Conceptual Review Agenda

Schedule for 04/11/16 to 04/11/16

102 Fossil Creek Pkwy Self-Storage

FOSSIL CREEK SELF-STORAGE

CONCEPT SITE PLAN

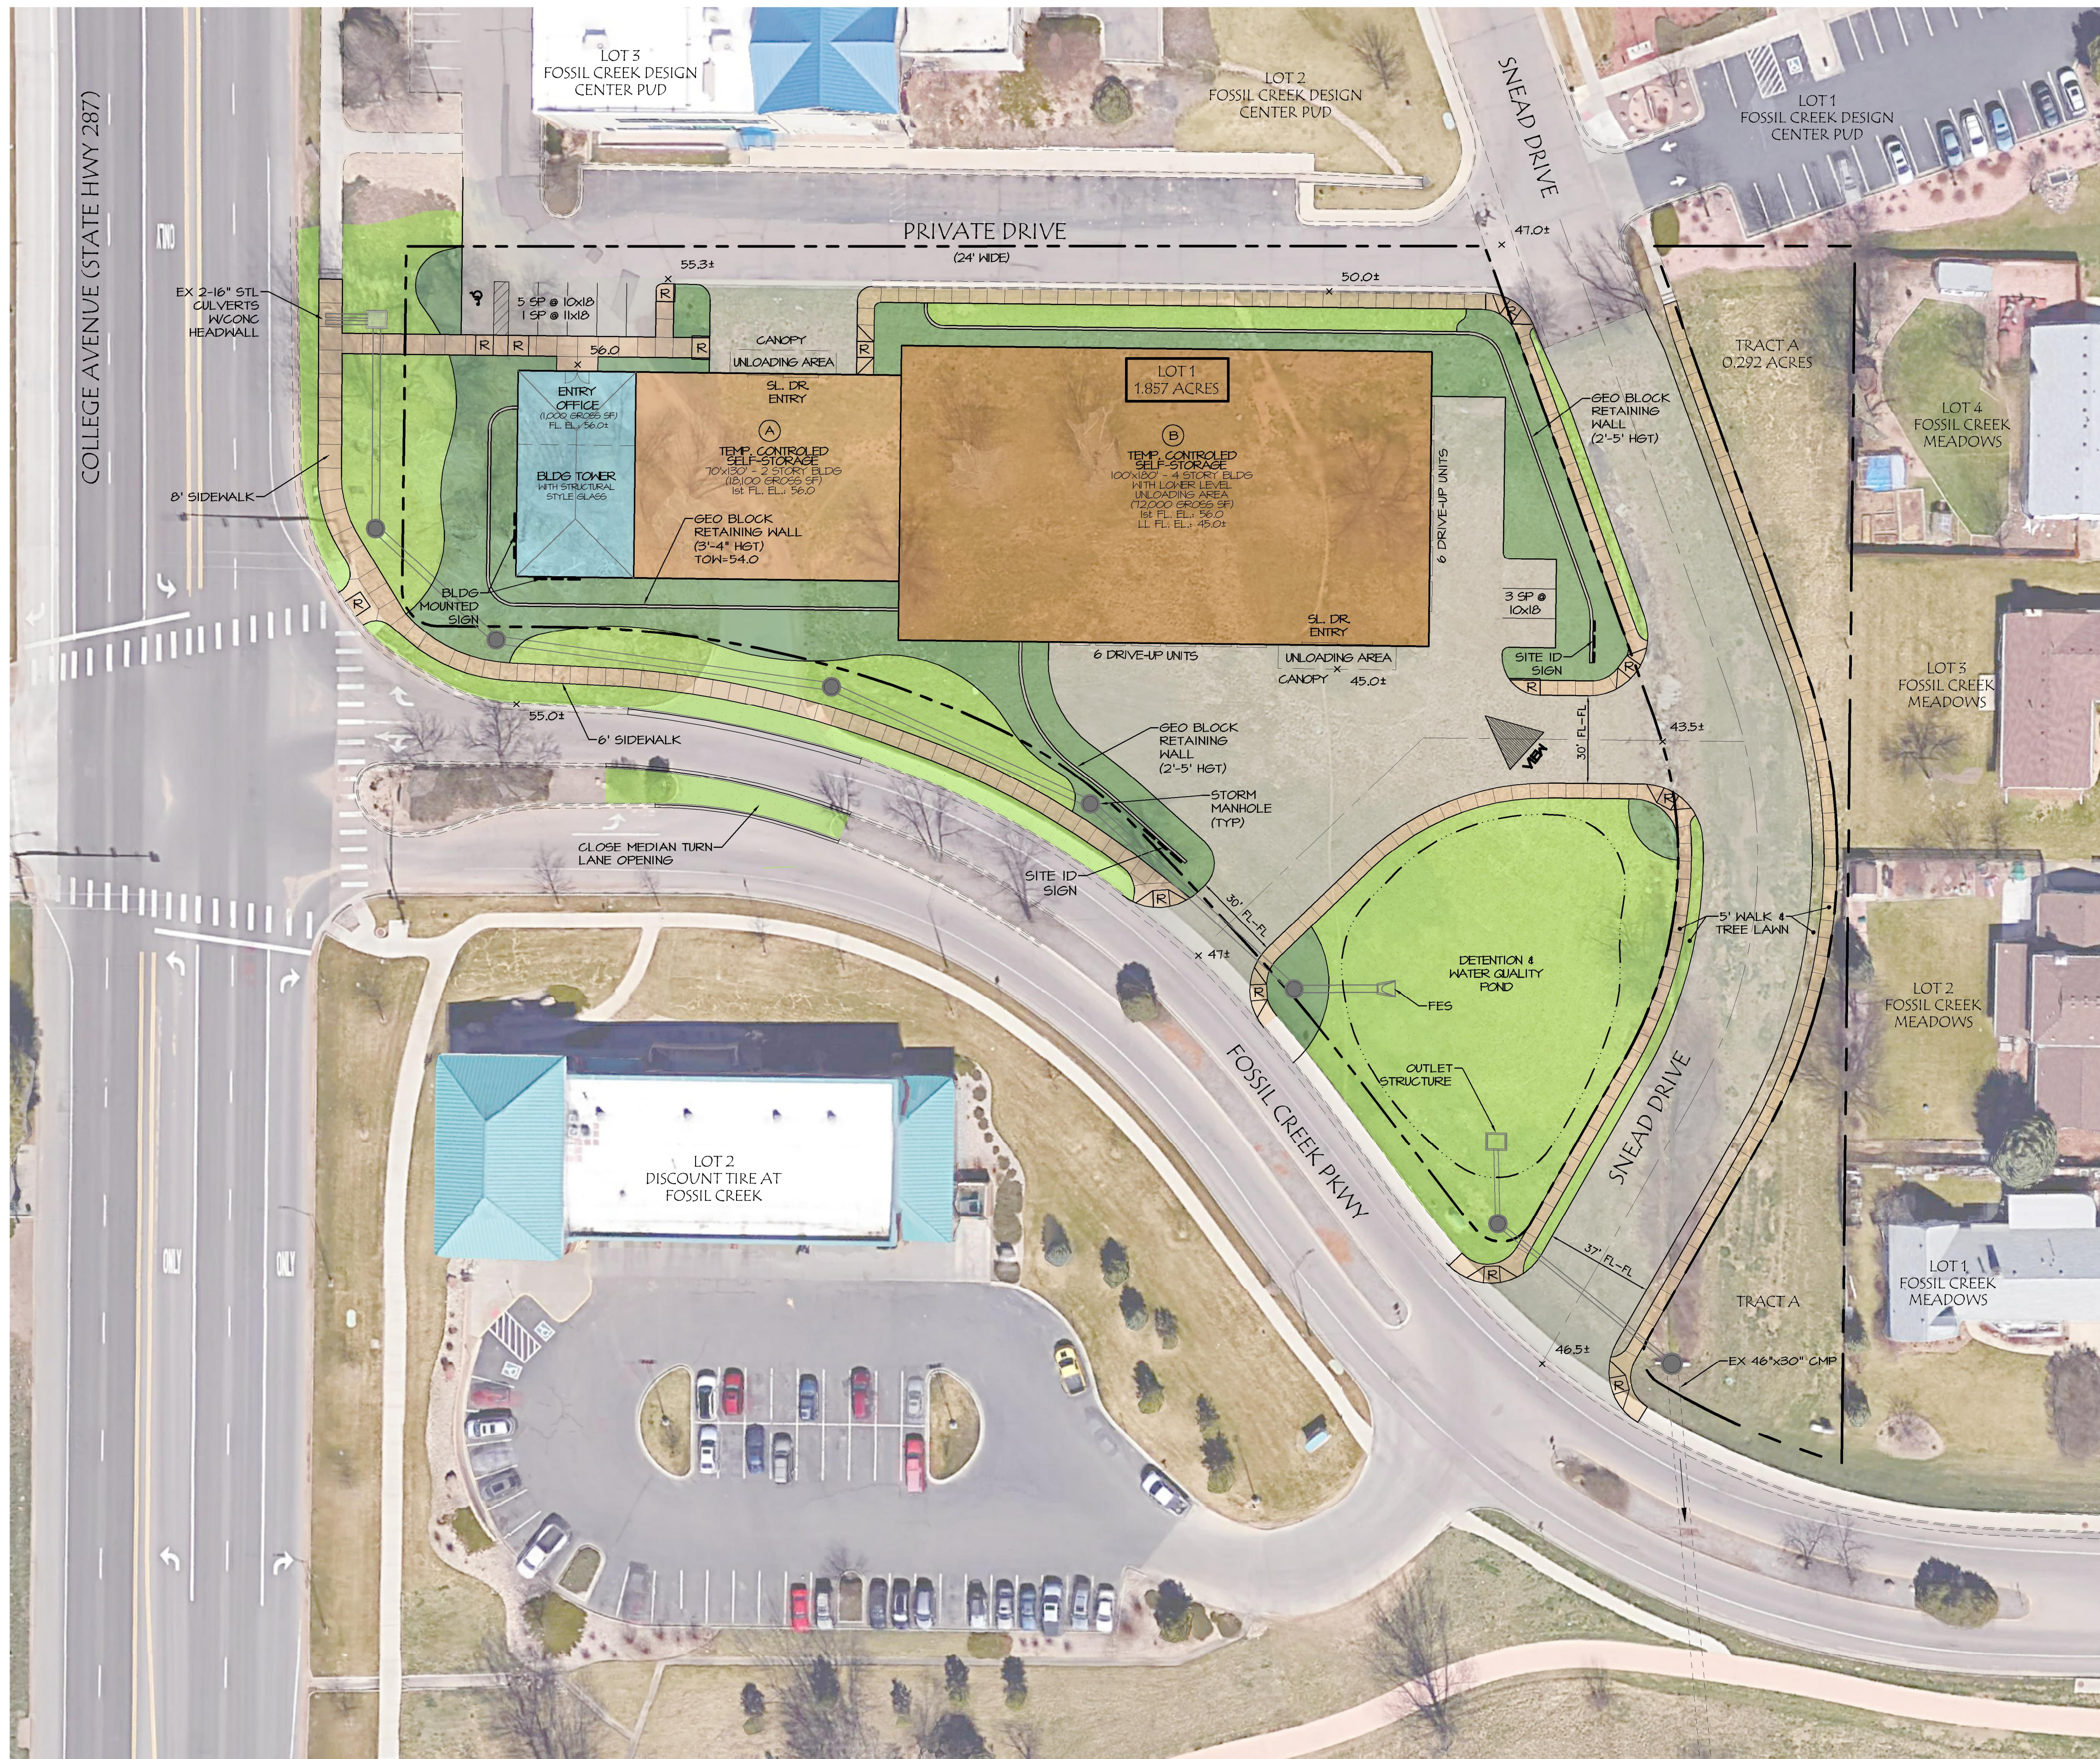
4. There are two existing drainage channels through the site that will need to be accommodated. It appears as though your conceptual site plan does account for the channel from College Avenue. Please note that the existing storm pipe daylighting into this site from

College Avenue is a 24" RCP. City documentation and the sub-basin analysis of the Fossil Creek Master Drainage Plan does not indicate how this 24" RCP pipe was sized. However, roadside drainage from the east side of College Avenue extending north to Mason Street appears to drain towards this storm pipe, as well as a section of College Avenue on the west side near Coronado Drive. The swale within/adjacent to Snead Drive is temporary and will need to be piped within Snead Drive as a part of this development. Additionally, there is runoff from the property to the north that will need to be routed through this development.

Fire access is required within 150' of all exterior portions of all building perimeters. Fire access cannot be measured from an arterial road and therefore fire lanes will be required on both North and South sides of the building. Fire lanes shall be dedicated as Emergency Access Easements. This shall apply to the cross-property drive aisle on the north side of the building. Due to the length of the fire lane, it will either need to provide an approved turnaround or continue through the north property and connect to the public way. NO PARKING - FIRE LANE signage will also be required. Code language and fire lane

16. A Development Construction Permit (DCP) will need to be obtained prior to starting any work on the site.
17. LCUASS parking setbacks (Figure 19-6) apply and will need to be followed depending on parking design. It appears that the access off of Fossil Creek Parkway may be an issue.

1. How does the proposed plan meet the build to line standards outlined in Land Use Code section 3.5.3(C)(2)? The loading area shown would be in conflict with this standard. Staff would prefer the loading area to be located on the northern portion of the site so that loading occurs on the private drive.

4. It appears you are proposing to remove most if not all of the existing trees on site. Your landscape plan will need to clearly identify how you will be mitigating for the loss of these trees. Please provide a table that outlines how many trees will be removed and how many mitigation trees are required. On the landscape plan, please clearly label which trees are being used for mitigation purposes.

5. How wide is the sidewalk for the parking area shown on the northern portion of the site? If the sidewalk is wider than 6 feet then the 18 foot parking stall depth will be adequate as long as the parking stalls are separated from the sidewalk via curb or wheel stop. Please clearly show the curb or wheel stops on the site plan when you submit for a PDP.
